**Philippine Atmospheric, Geophysical and Astronomical Services Administration (PAGASA)**

**SUPPLEMENTAL / BID BULLETIN No. 2019-021-02 & 2019-022-02**

- Subject:**
1. **Supply, Delivery, Installation, Testing and Commissioning of One (1) Unit 340 KVA Three-Phase Generator Set for the Wind Tunnel of Mactan Cebu PAGASA Station Complex (Re-bid)**  
**Reference: PR No. 2018-10-0718 / IB No. 2019-021**  
**ABC: Php4,196,967.51**
  2. **Supply, Delivery, Installation, Testing and Commissioning of One (1) Unit 200 KVA Three Phase Generator Set for the Wind Tunnel of Davao PAGASA Station Complex (Re-bid)**  
**Reference: PR No. 2018-09-0684 / IB No. 2019-022**  
**ABC: Php3,164,822.33**

GEN. PEDESTAL FOOTING DETAIL  
 SCALE 1:50 MTS

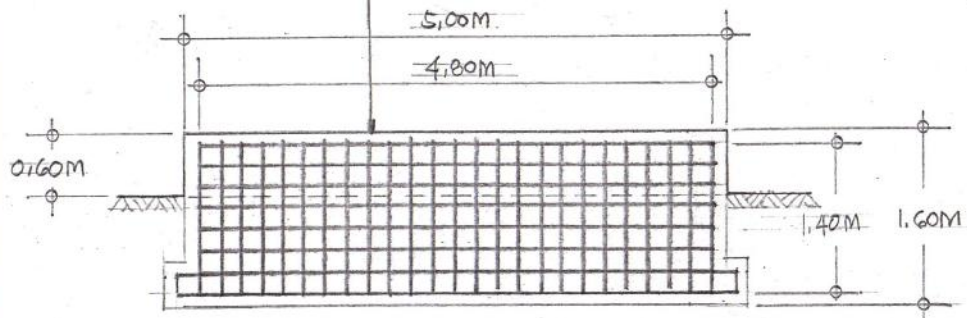
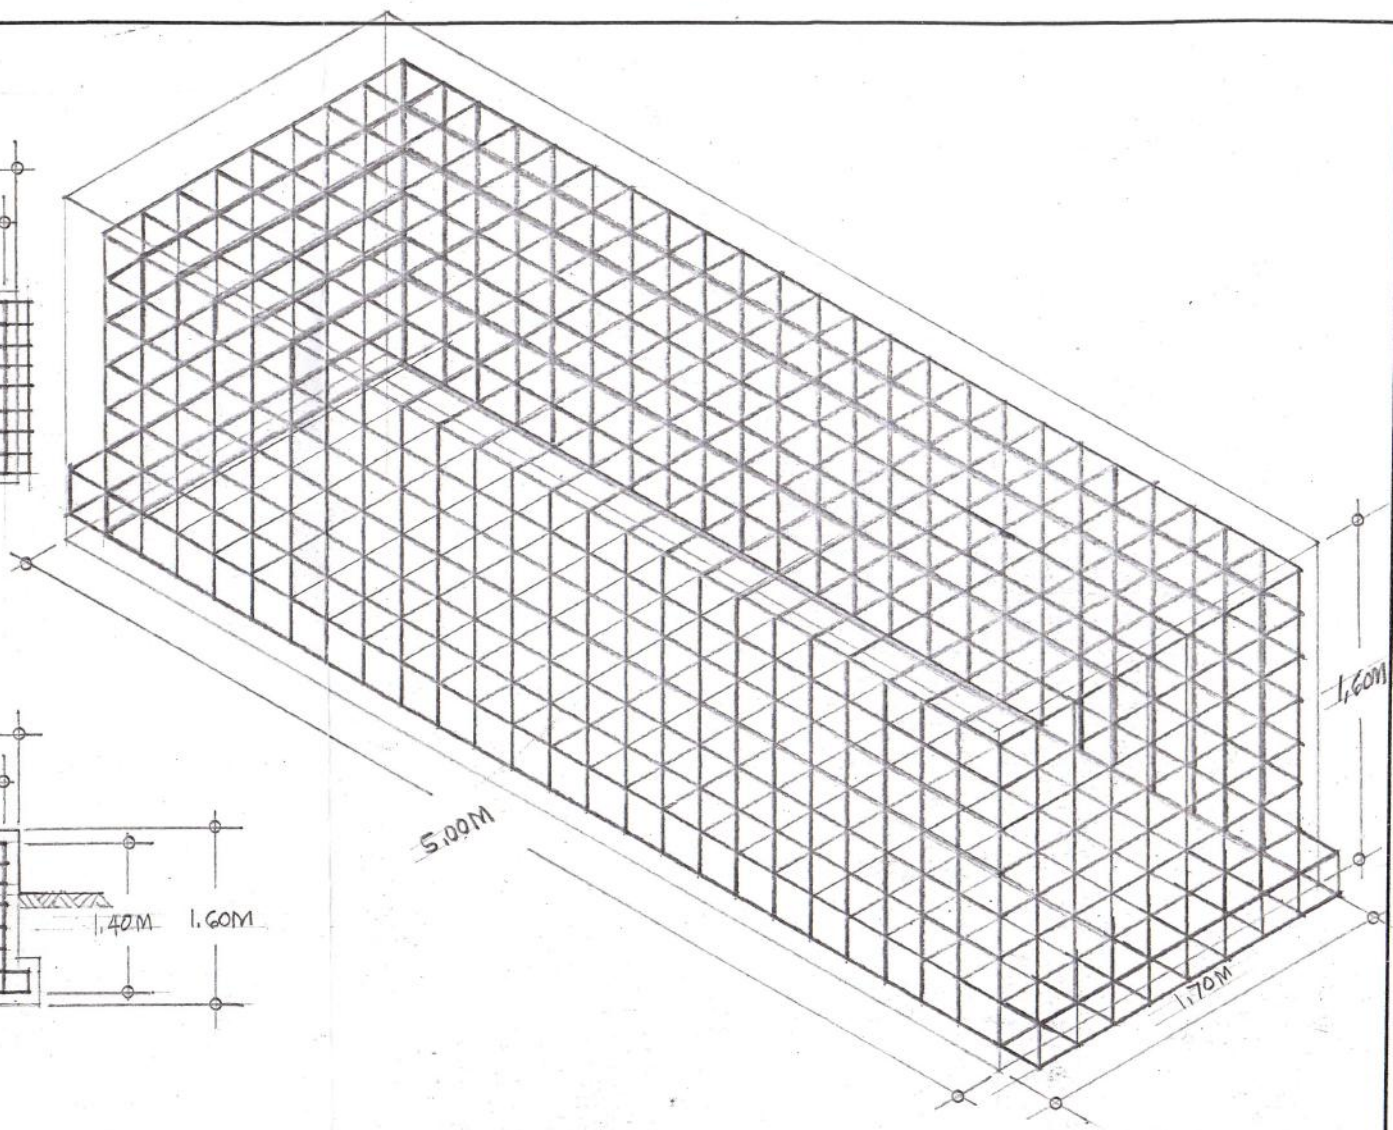
<b>Query No.</b>	<b>Particulars</b>	<b>Answers</b>
1.	<p>On the Generator Technical Specifications:</p> <p>a. Fuel Tank Capacity -</p> <p>May we propose manufacturer's standard with minimum 8 hrs operating capacity?</p> <p>b. Dimension and Dry Weight –</p> <p>May we propose manufacturer's standard?</p>	<p>a. The Fuel Tank Capacity of the Generator sets for the Cebu and Davao PAGASA Stations, above is hereby amended as follows:</p> <ul style="list-style-type: none"> <li>• For <u>Cebu PAGASA Station</u></li> </ul> <p><b>From: 400 L</b></p> <p><b>To: 400 L; or, manufacturer's standard with minimum 8 hrs capacity under 75% load.</b></p> <ul style="list-style-type: none"> <li>• For <u>Davao PAGASA Station</u></li> </ul> <p><b>From: 330 L</b></p> <p><b>To: 330 L; or, manufacturer's standard with minimum 8 hrs capacity under 75% load.</b></p> <p>b. PAGASA has a readily available foundation plans for the generator sets with complete details as shown in the attached <b>Annex "A"</b> of this Bid Bulletin. The offered generator set must fit in to the foundation depicted therein.</p> <p>The foundation design is based on the weight of 3,150 kilograms.</p>
